ADDENDUM NO. 2

Replace Fire Alarm Panels - Infrastructure
Eastern Reception and Diagnostic Correctional Center
Bonne Terre, Missouri
PROJECT No.: C2405-01

Bidders are hereby informed that the construction Plans and/or Specifications are modified as follows:

SHEET NUMBER:
FA-002

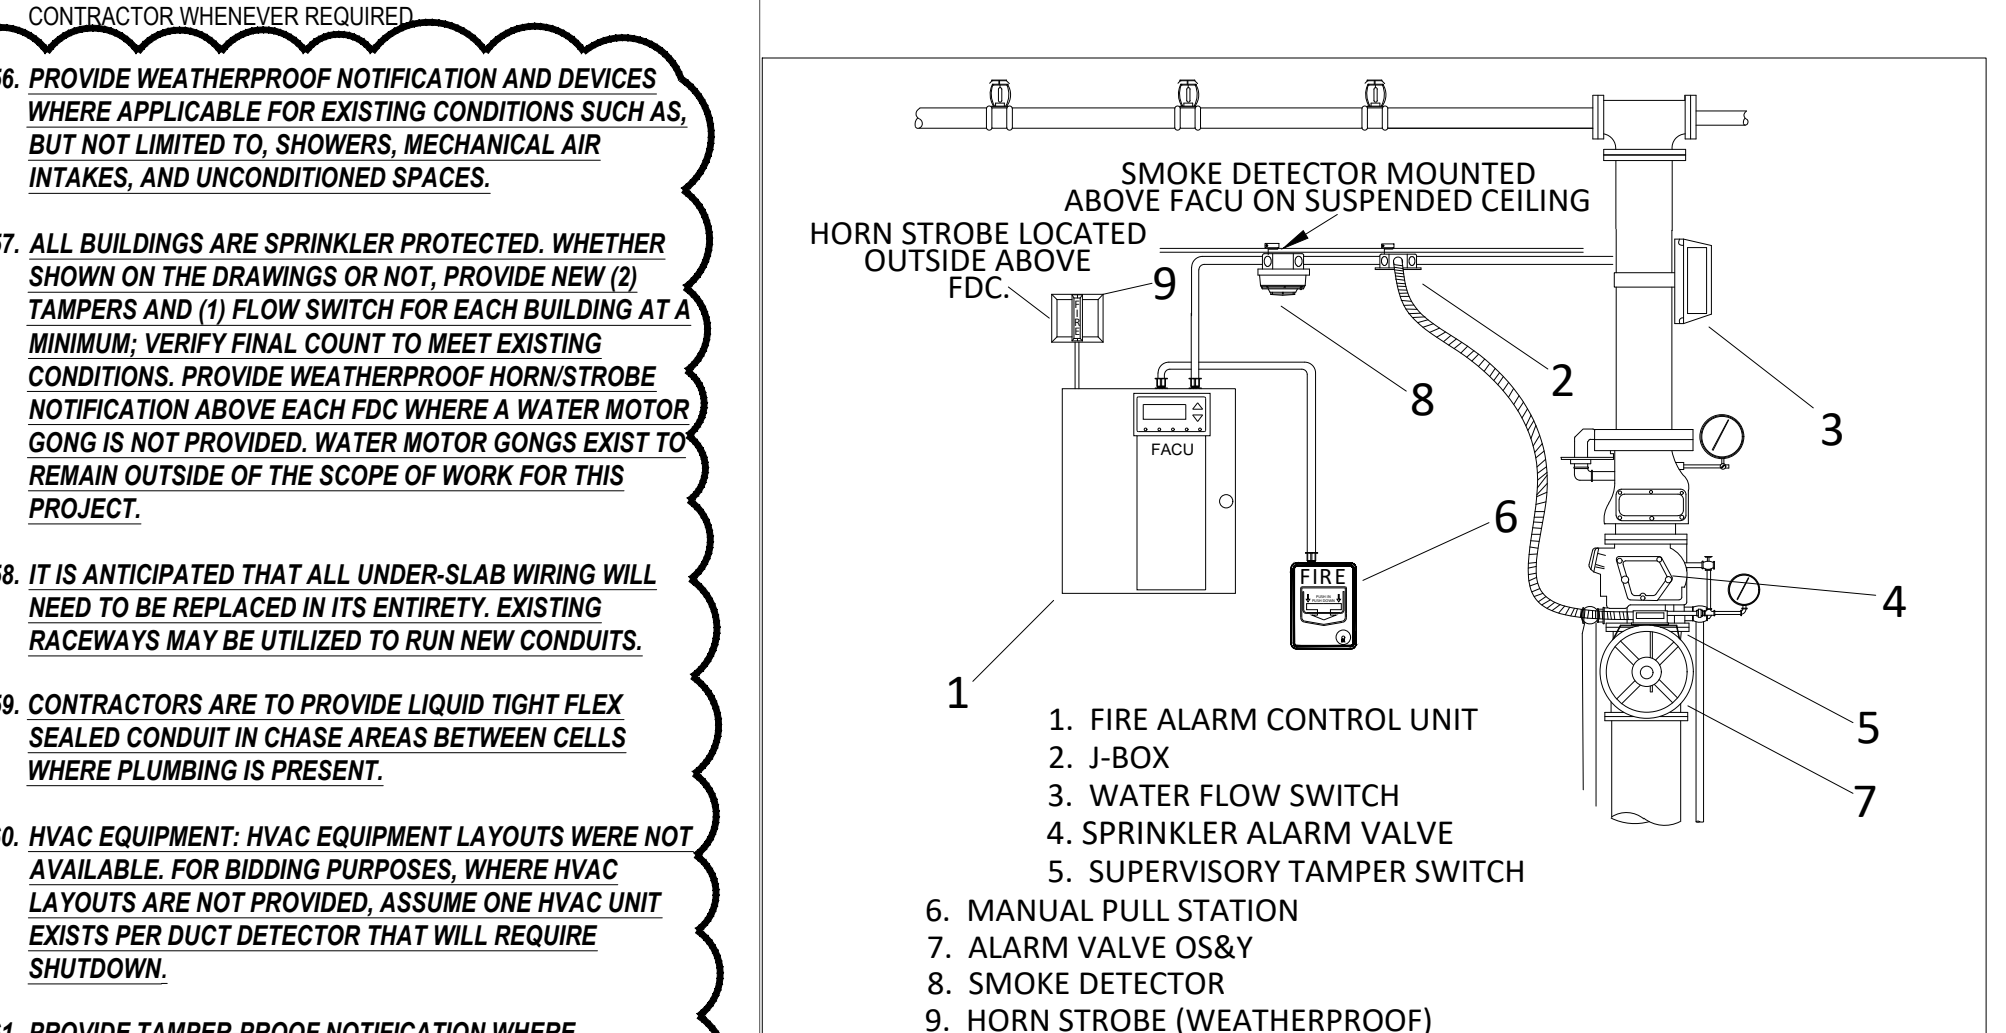
1. Sheet FA-002
 - a. General Notes 56, 57, 58, 59, 60, 61, 62 were added.
 - b. See attached revised drawing.
2. Sheet FA-100
 - a. Key Note 6 was added.
 - b. See attached revised drawing.
3. Sheets FA-200
 - a. Annunciator was added at door entry adjacent to Driver's Lounge (Room 112).
 - b. See attached revised drawing.
4. Sheet FA-402
 - a. NAC and smoke detector was added to Room D107.
 - b. See attached revised drawing.
5. Sheet FA-700
 - a. Two duct detectors were added to HVAC unit serving Gymnasium 115.
 - b. See attached revised drawing.
6. Sheet FA-901
 - a. A second duct detector per chase was added for cell housing.
 - b. See attached revised drawing.

- ALL BUILDINGS ARE SPRINKLER PROTECTED. WHETHER SHOWN ON THE DRAWINGS OR NOT, PROVIDE NEW (2) TAMPERS AND (1) FLOW SWITCH FOR EACH BUILDING AT A MINIMUM. VERIFY FINAL COUNT TO MEET EXISTING CONDITIONS. PROVIDE WEATHERPROOF HORN/STROBE NOTIFICATION ABOVE EACH FDC WHERE A WATER MOTOR GONG IS NOT PROVIDED. WATER MOTOR GONGS EXIST TO REMAIN OUTSIDE OF THE SCOPE OF WORK FOR THIS PROJECT.

- IT IS ANTICIPATED THAT ALL UNDER-SLAB WIRING WILL NEED TO BE REPLACED IN ITS ENTIRETY. EXISTING RACEWAYS MAY BE UTILIZED TO RUN NEW CONDUITS.
- CONTRACTORS ARE TO PROVIDE LIQUID TIGHT FLEX SEALED CONDUIT IN CHASE AREAS BETWEEN CELLS WHERE PLUMBING IS PRESENT.
